**TO:** Troy Kelts, Galloway & Company  
**FROM:** Stacey Nerger, Senior Planner  
**DATE:** November 15, 2023  
**SUBJECT:** The Exchange Lot 1 – Site Plan  
Review Comments 01

# PARKER EXCHANGE BUILDING SITE DEVELOPMENT PLAN

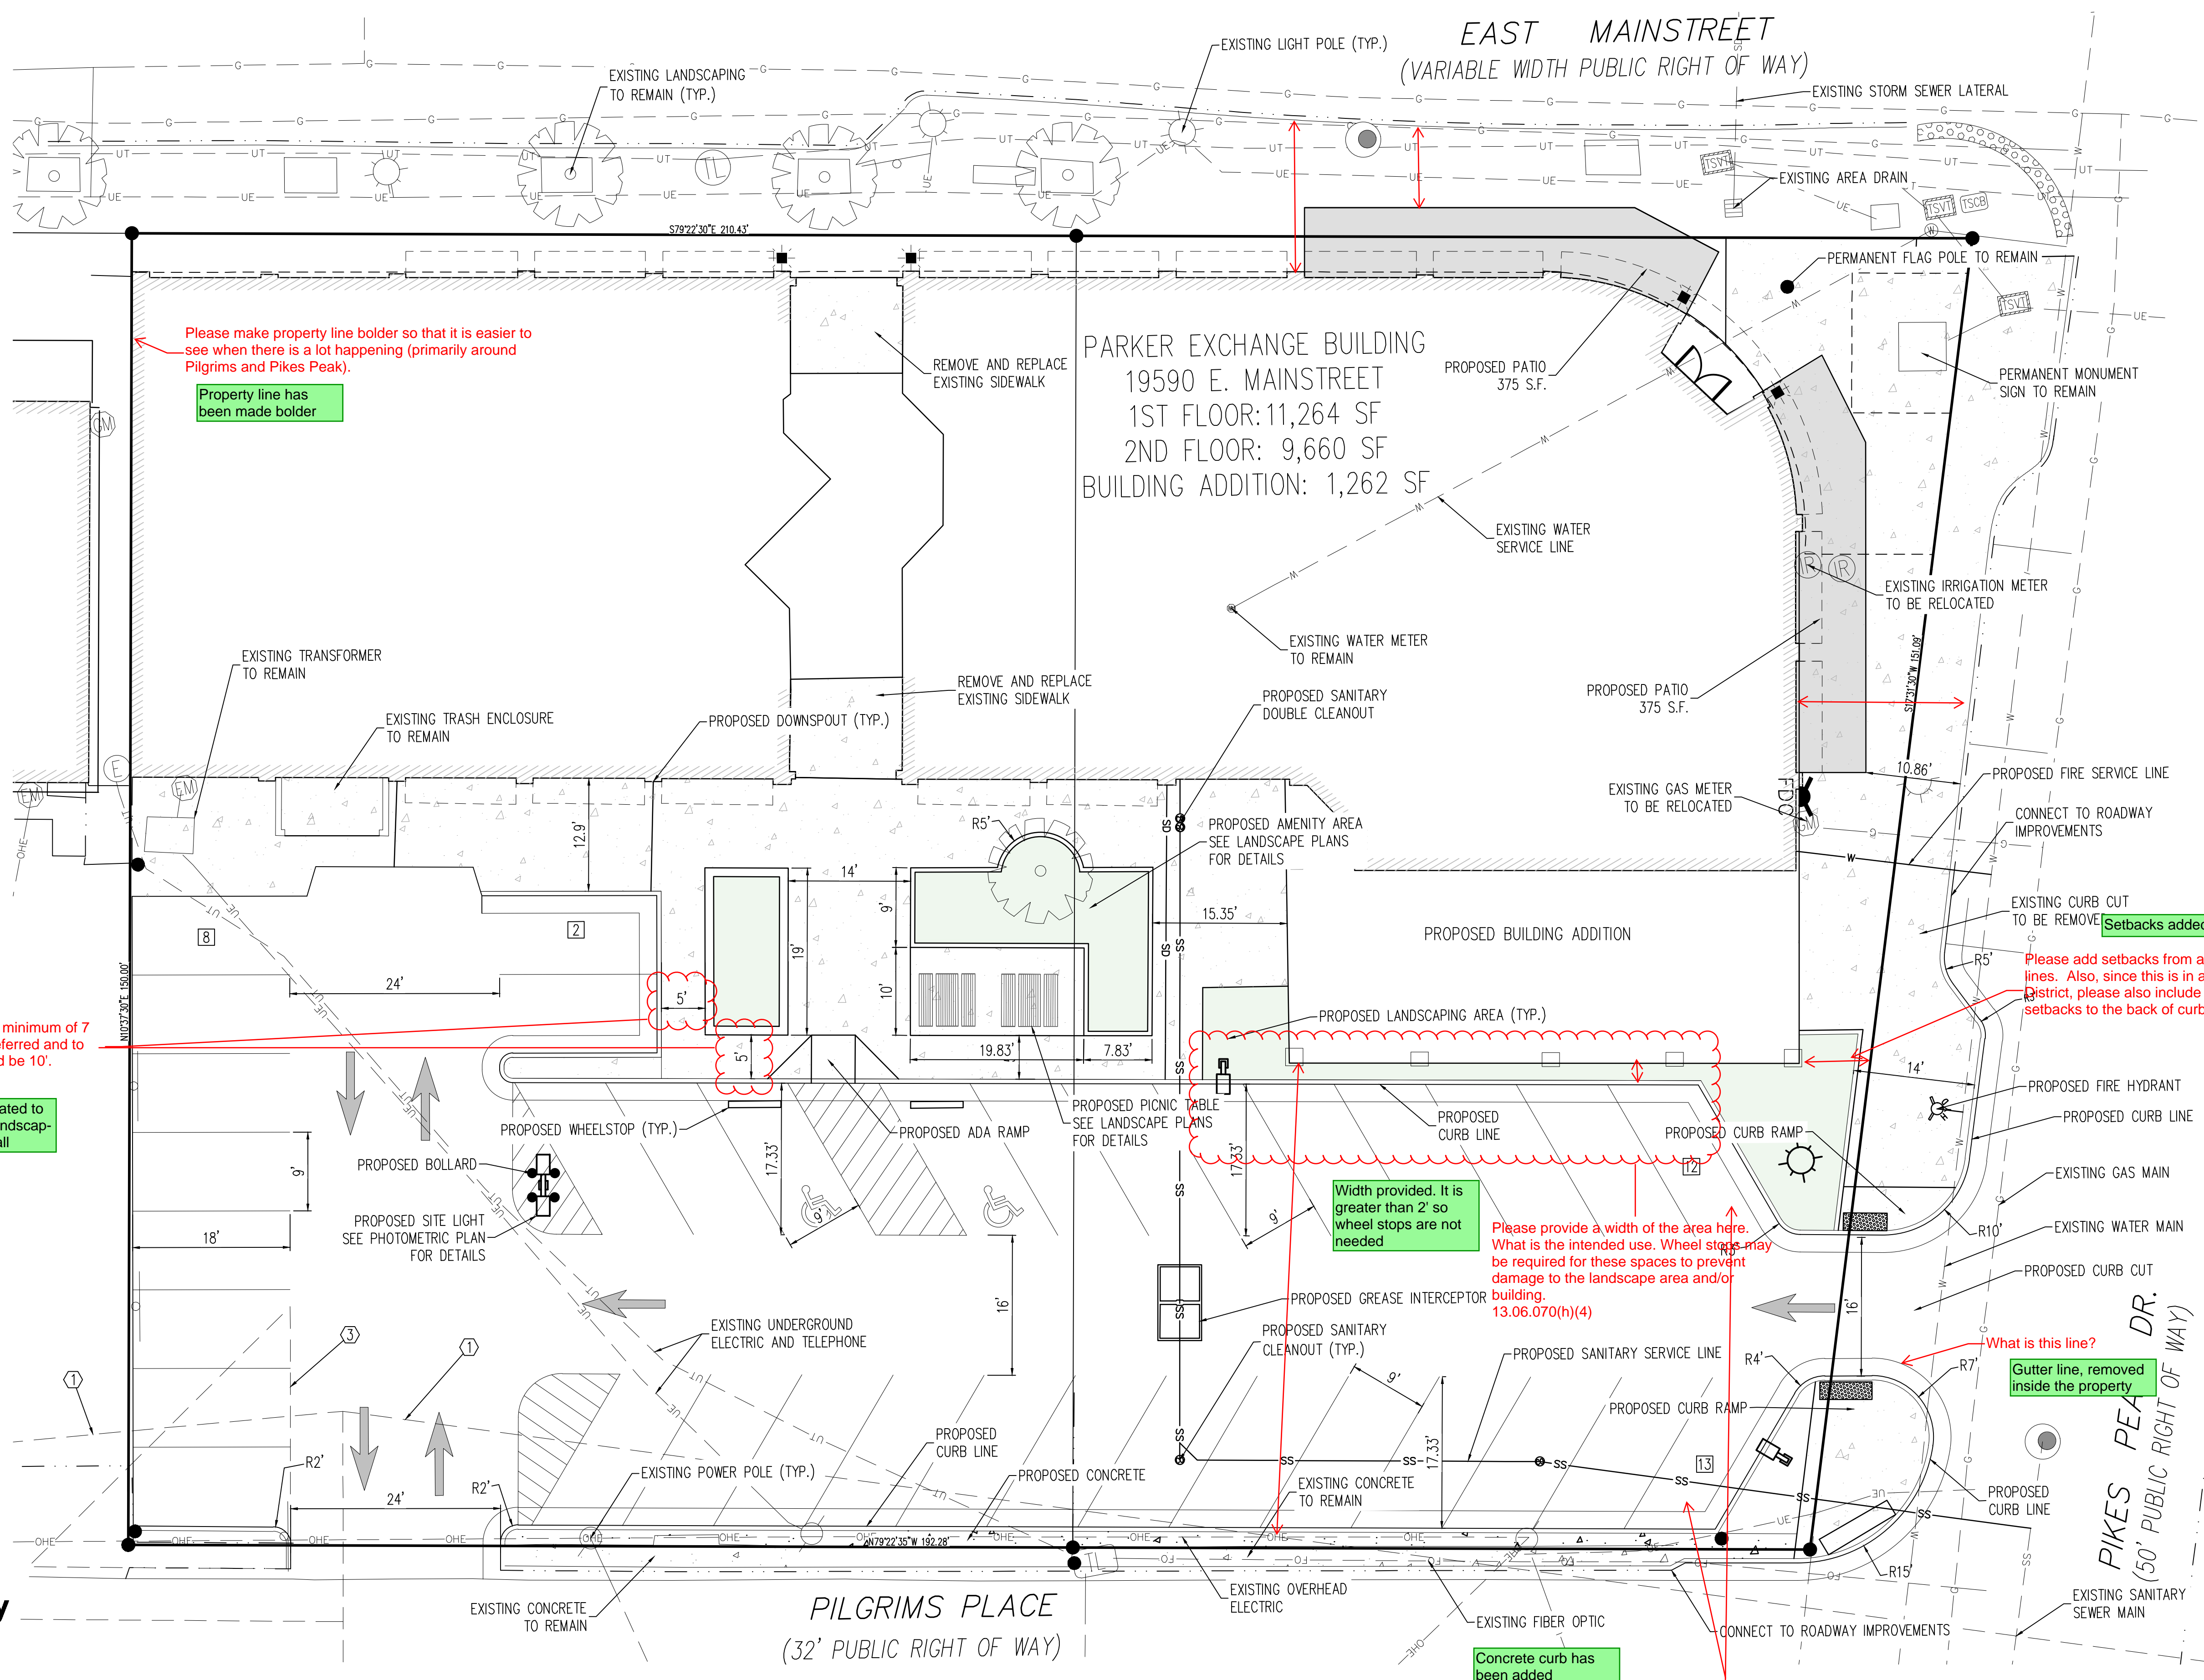
Please provide the distances as required by code. See Planning memo for more information.

Please make property line bolder so that it is easier to see when there is a lot happening (primarily around Pilgrims and Pikes Peak).  
Property line has been made bolder

Make these at a minimum of 7 feet in width, preferred and to meet code would be 10'.  
Sidewalk updated to expand the landscaping with sit wall

Please provide a width of the area here. What is the intended use. Wheel stops may be required for these spaces to prevent damage to the landscape area and/or building.  
13.06.070(h)(4)

Please add setbacks from all property lines. Also, since this is in a Downtown District, please also include the setbacks to the back of curb.

Distances provided

Concrete curb has been added

PHOTOMETRIC PLAN  
**5**  
5 OF 15

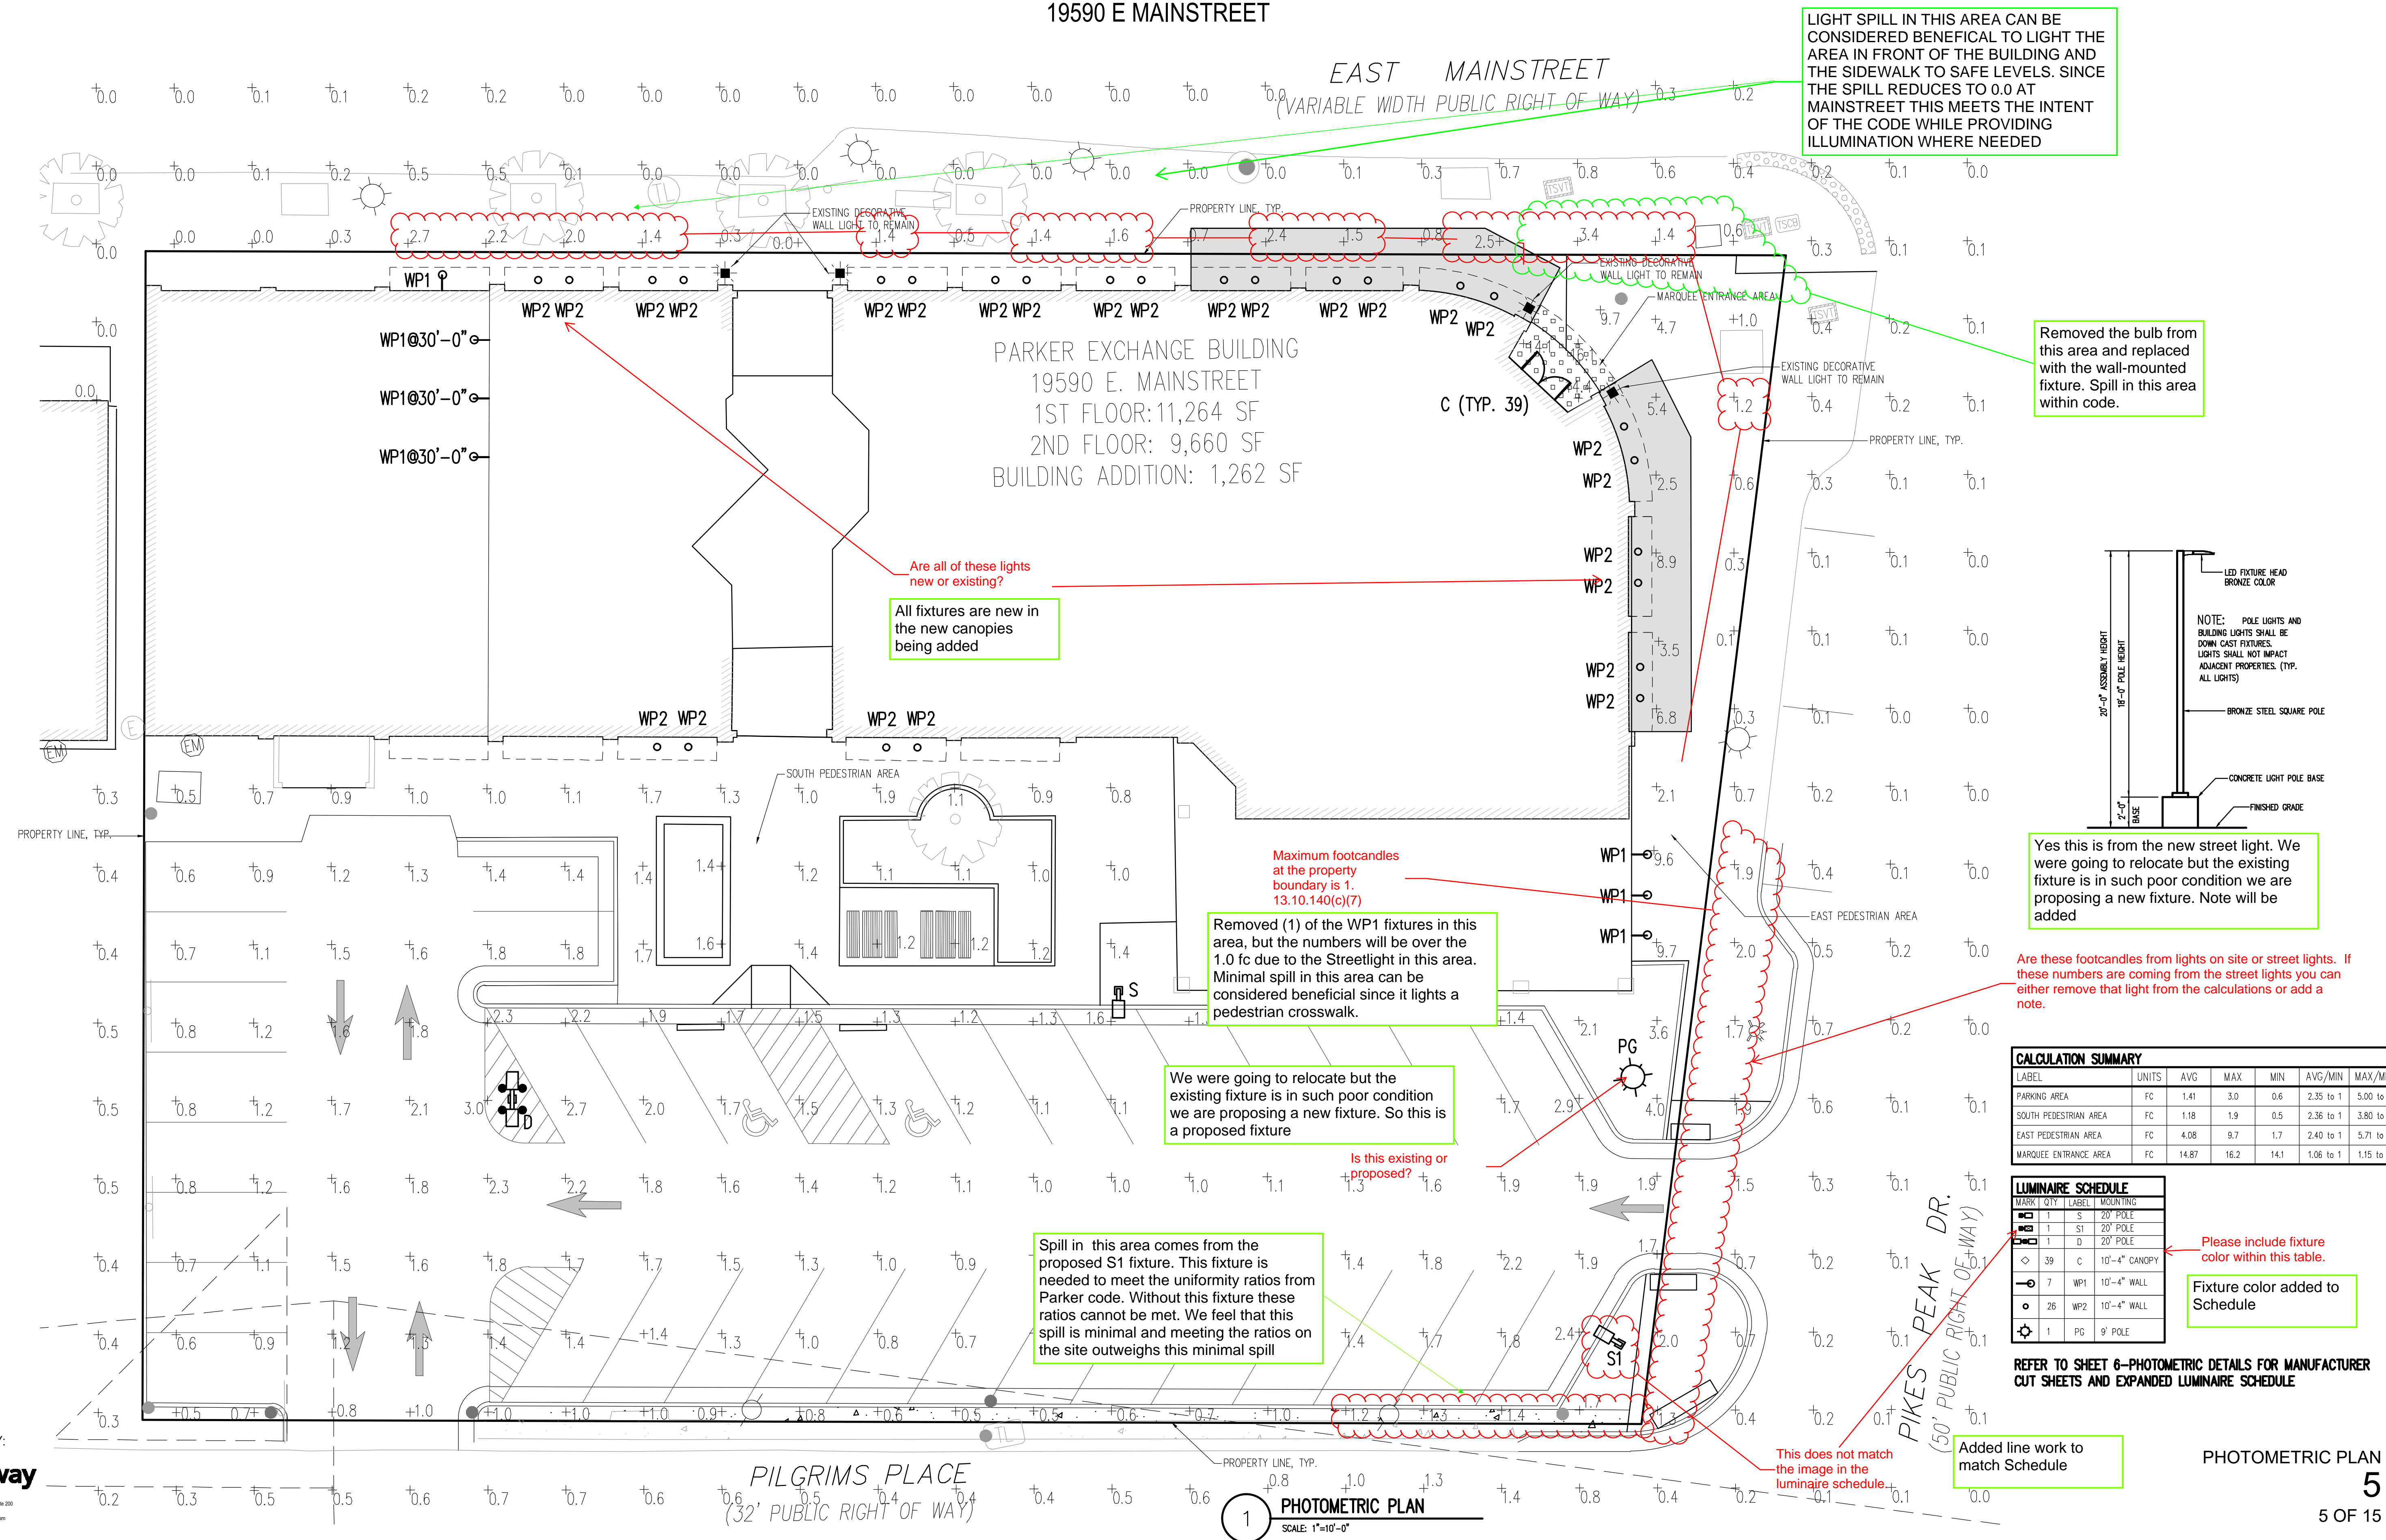
Please include fixture color within this table.  
Fixture color added to Schedule

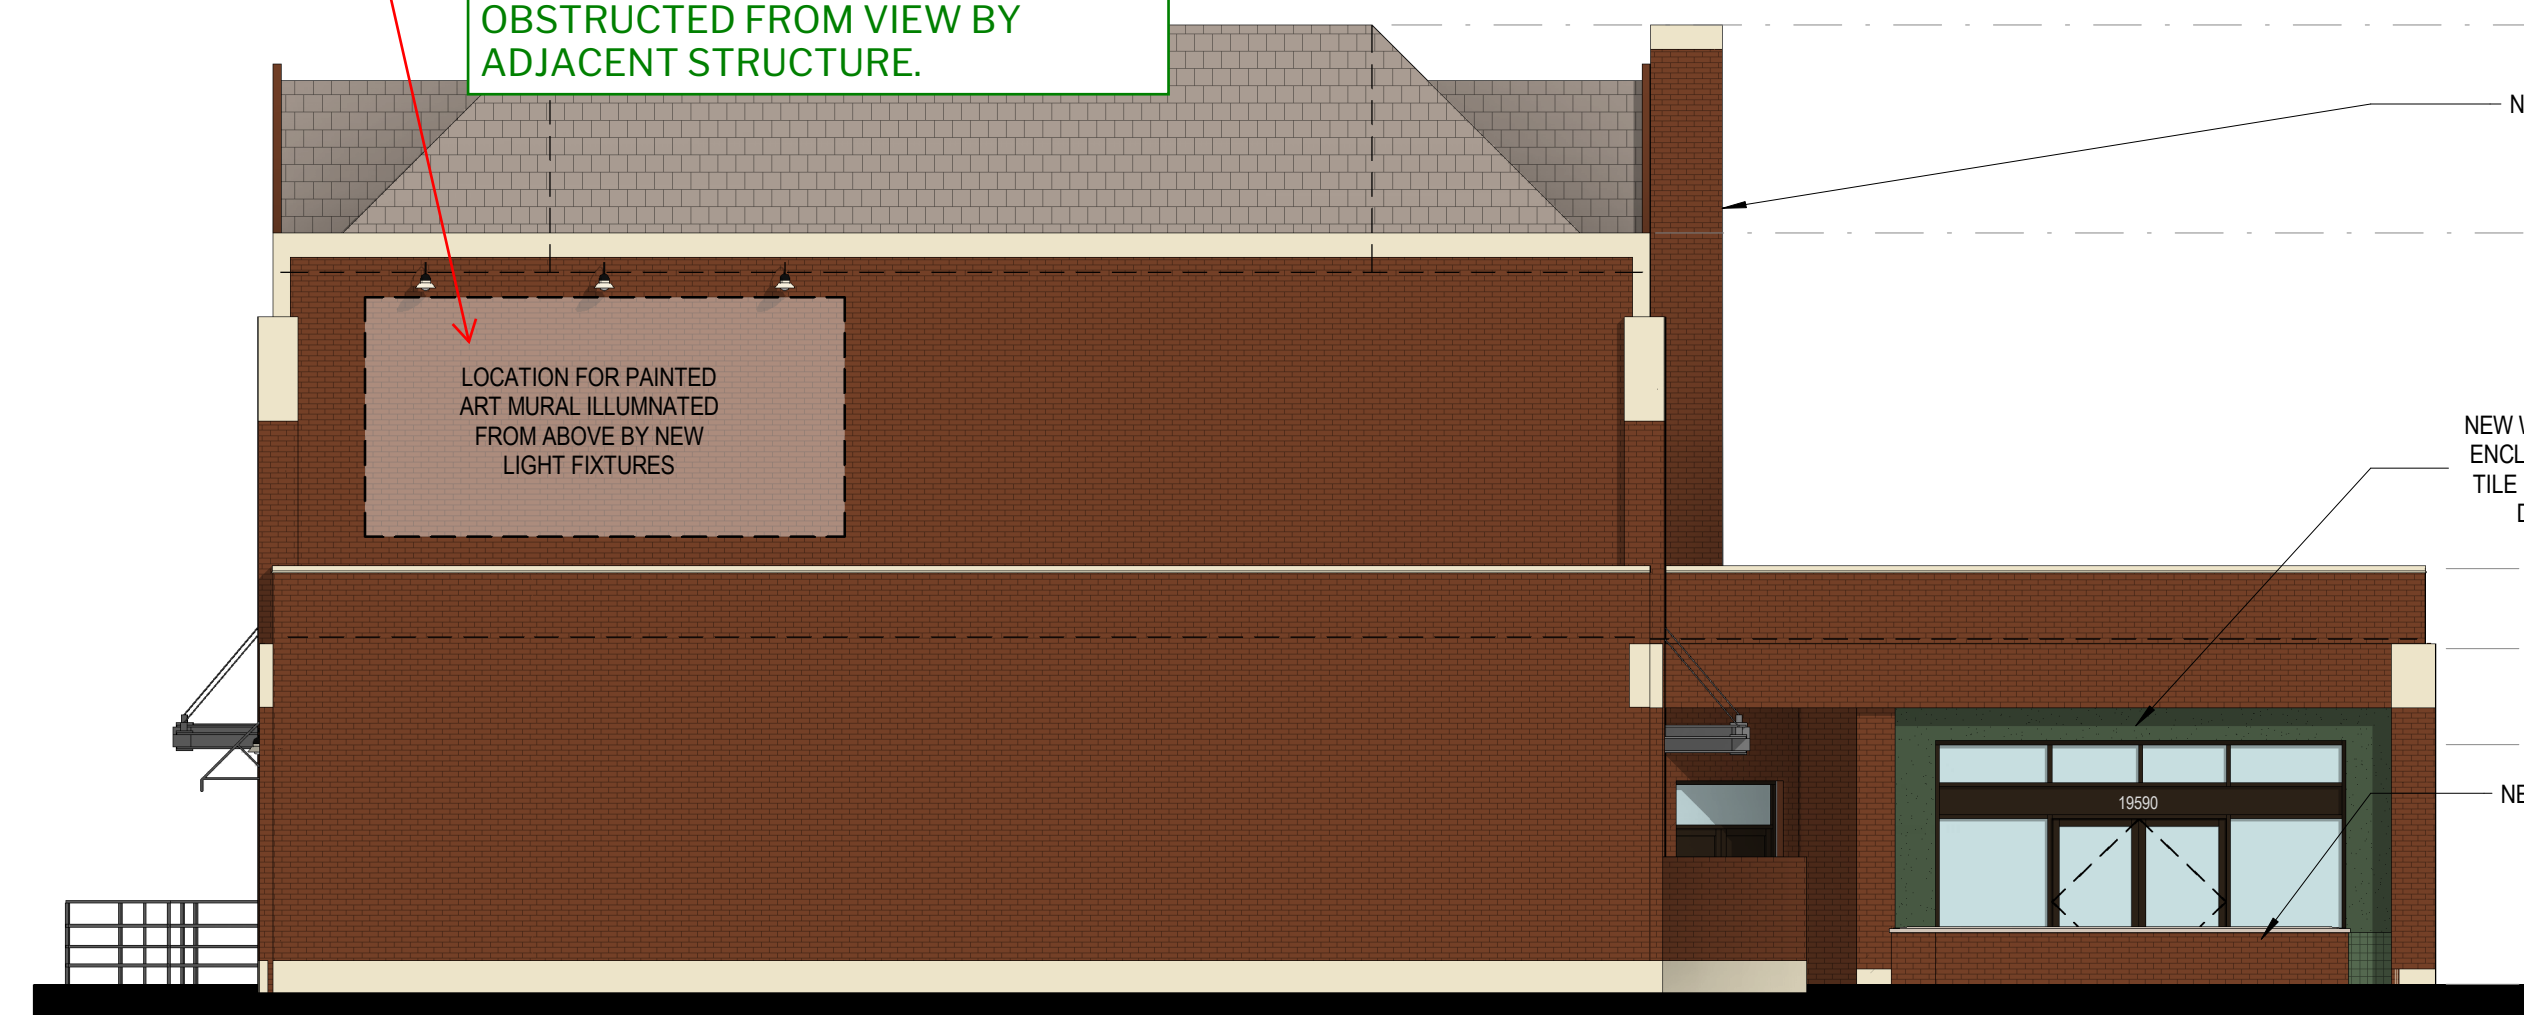
Please note signage requires a separate permit. Please remove all signage from the elevations to avoid confusion.

SIGNAGE HAS BEEN REMOVED FROM DRAWINGS.
